A NEW MEDICAL MARIJUANA DISPENSARY INTERIOR TENANT FINISH FOR:

GRD KIRKSVILLE, LLC
201 SE MO-291
LEE'S SUMMIT, MISSOURI 64063

- RESPONSE TO PLAN REVIEW COMMENTS (5/23/2022)
1. PATIENT TOILET 104 IS MODIFIED TO PROVIDE THE MINIMUM 18" CLEARANCE AT LATCH SIDE OF DOOR.
 2. A BOTTLED WATER APPLIANCE SHALL BE PROVIDED.

COVER SHEET

OCCUPANCY & EGRESS PLAN
SCALE: 1/4" = 1'-0"

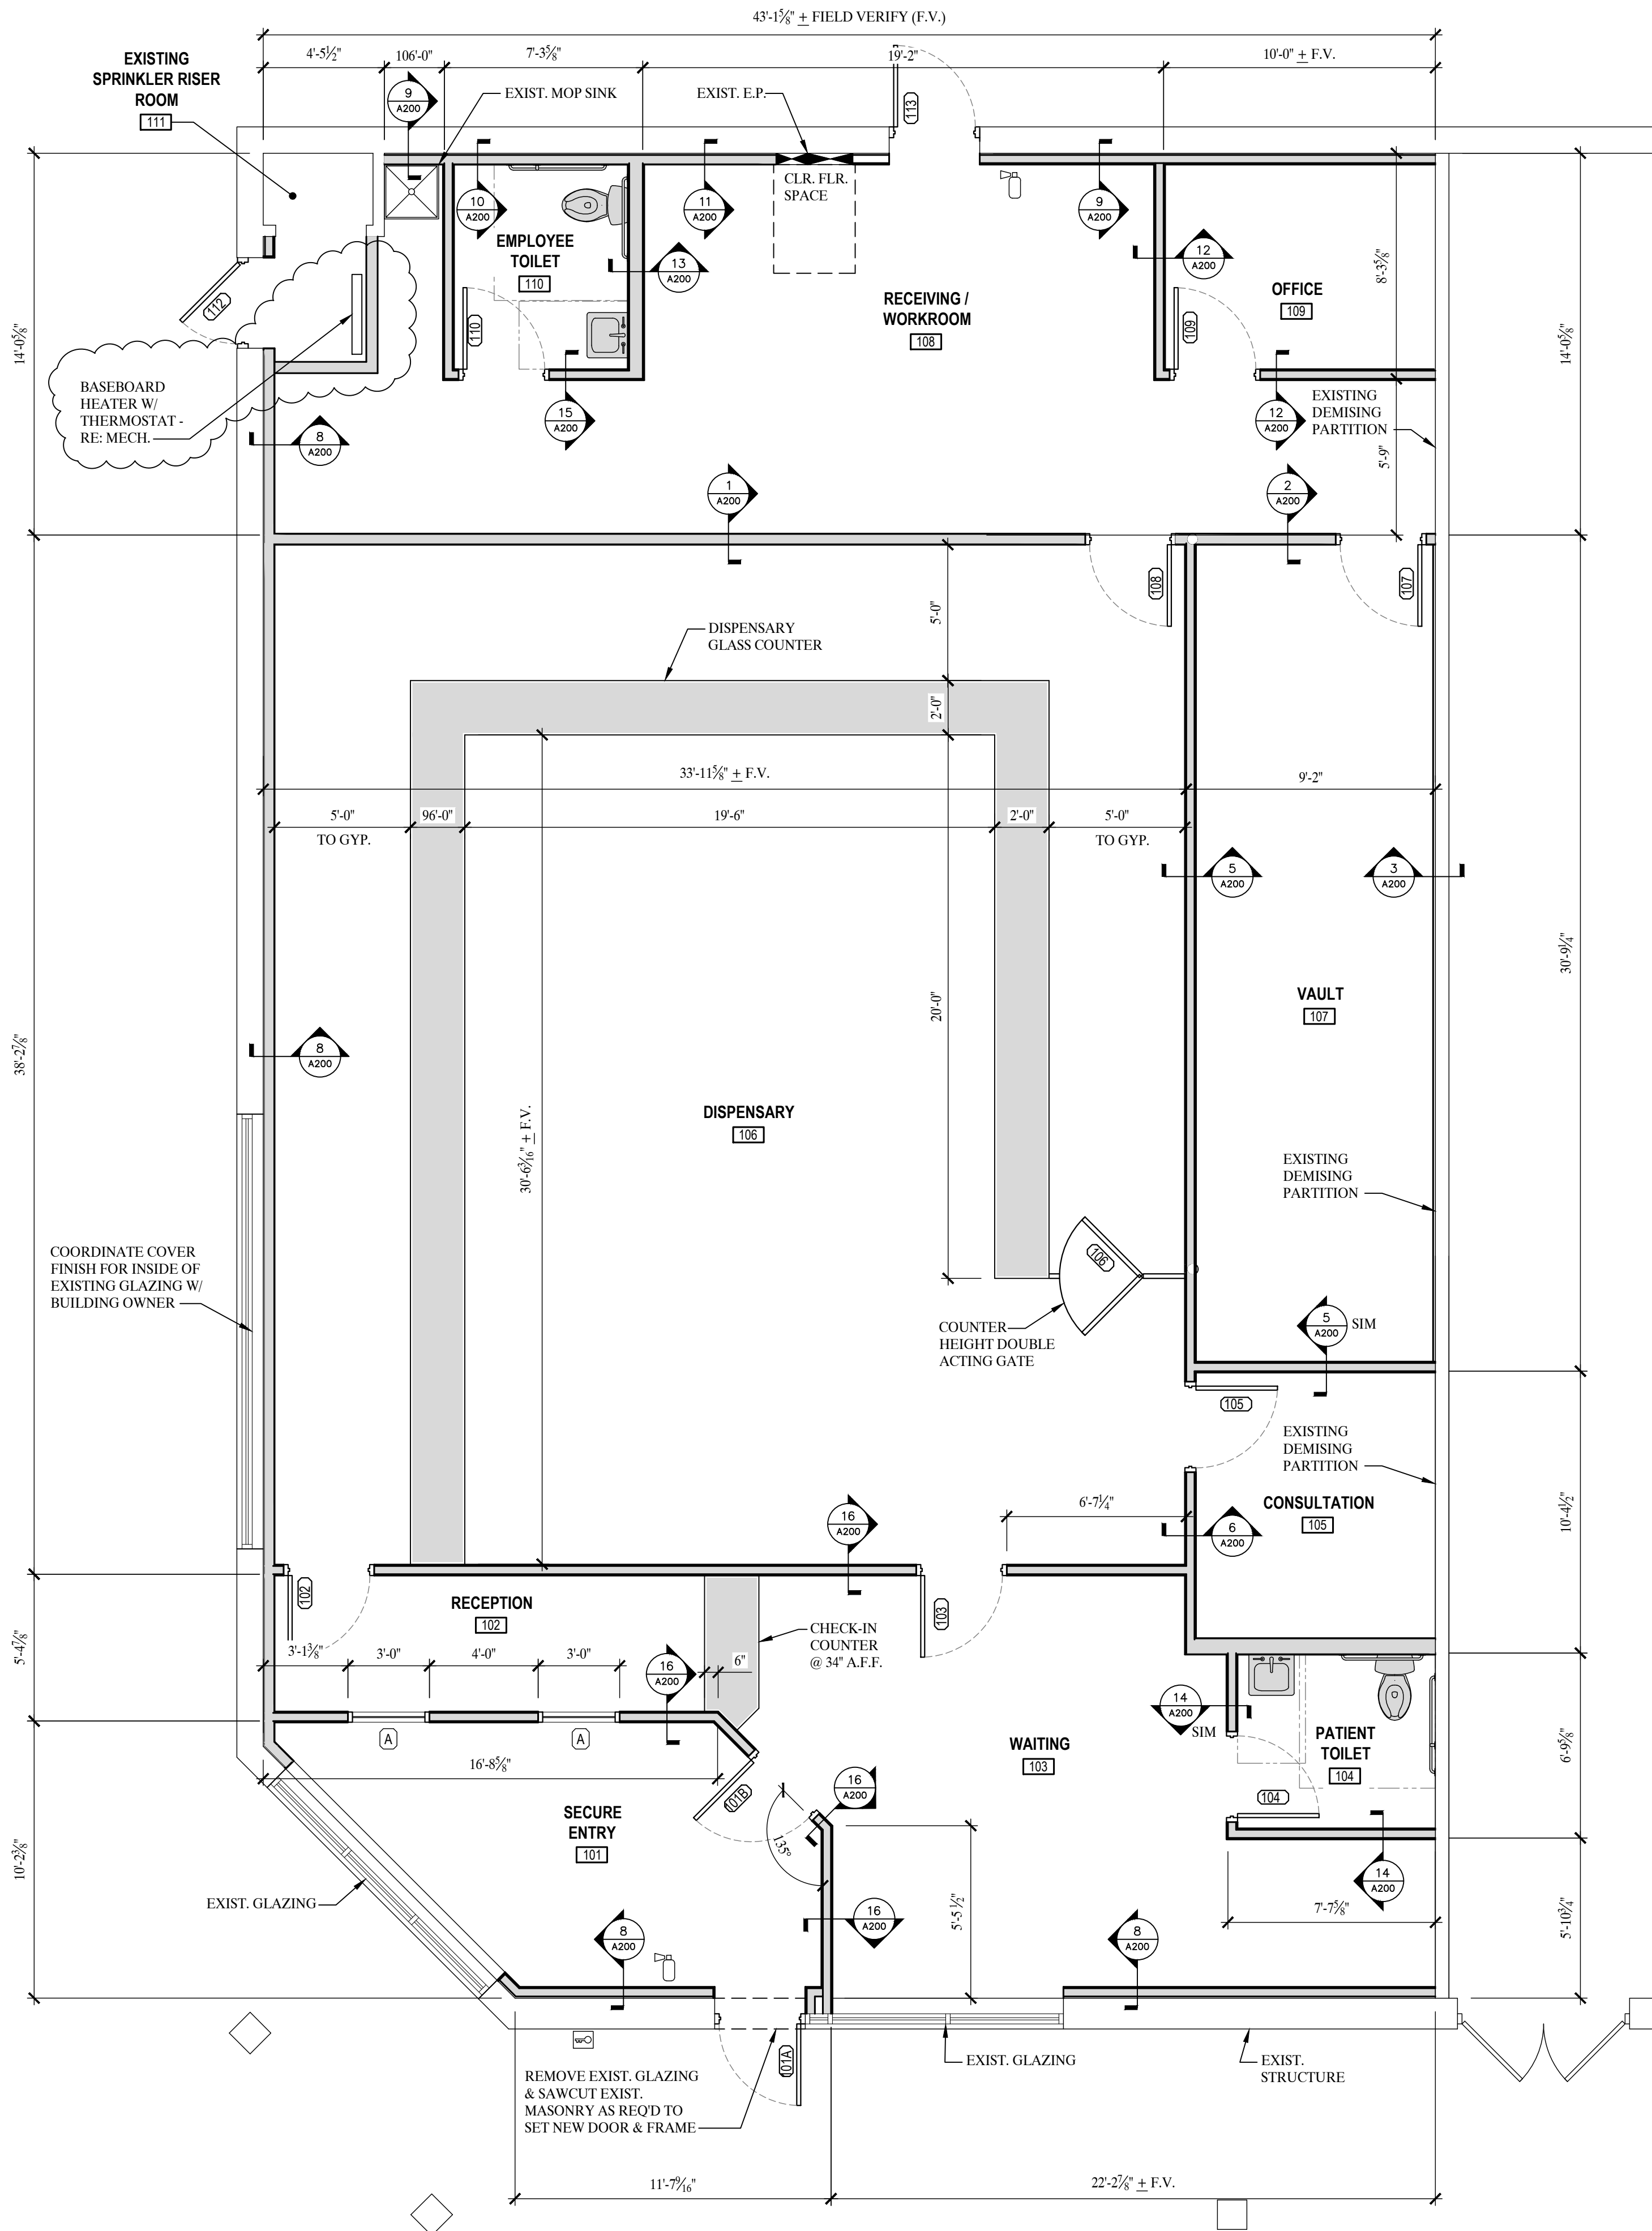
- RESPONSE TO PLAN REVIEW COMMENTS (5/23/2022)
- PATIENT TOILET 104 IS MODIFIED TO PROVIDE THE MINIMUM 18" CLEARANCE AT LATCH SIDE OF DOOR.
 - A BOTTLED WATER APPLIANCE SHALL BE PROVIDED.

**FLOOR PLAN,
INT.
ELEVATIONS**

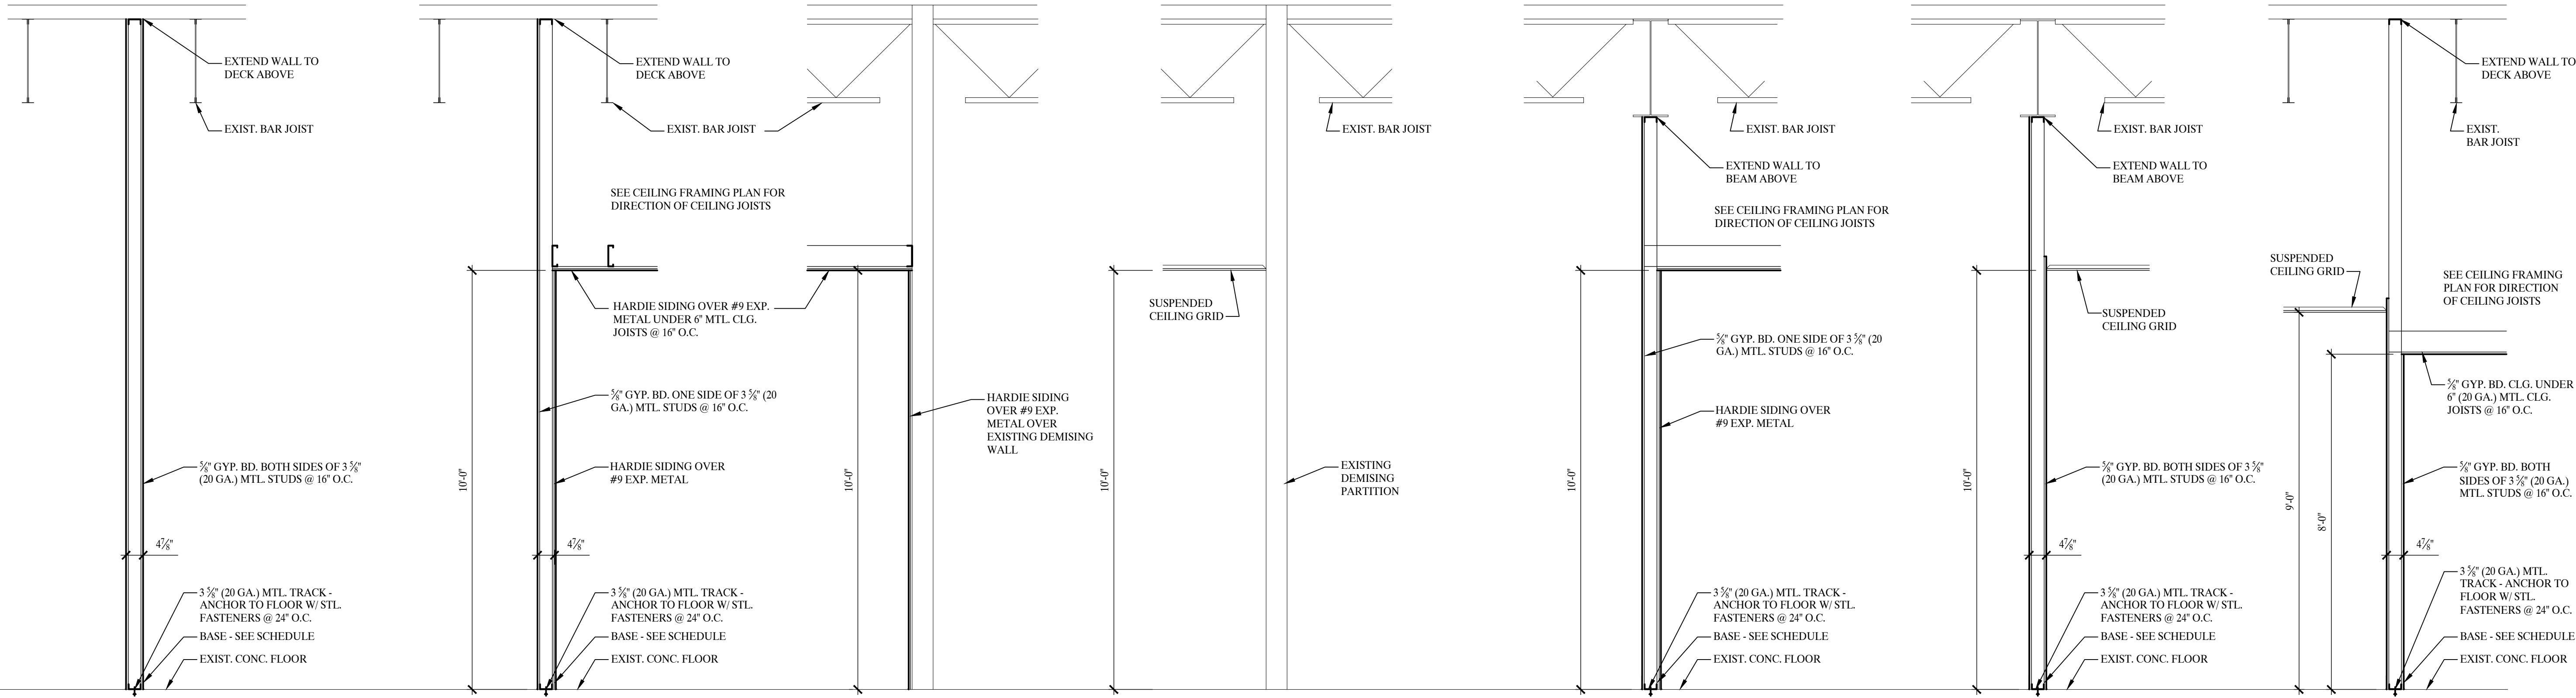
- RESPONSE TO PLAN REVIEW COMMENTS (5/23/2022)**
- PATIENT TOILET 104 IS MODIFIED TO PROVIDE THE MINIMUM 18" CLEARANCE AT LATCH SIDE OF DOOR.
 - A BOTTLED WATER APPLIANCE SHALL BE PROVIDED.
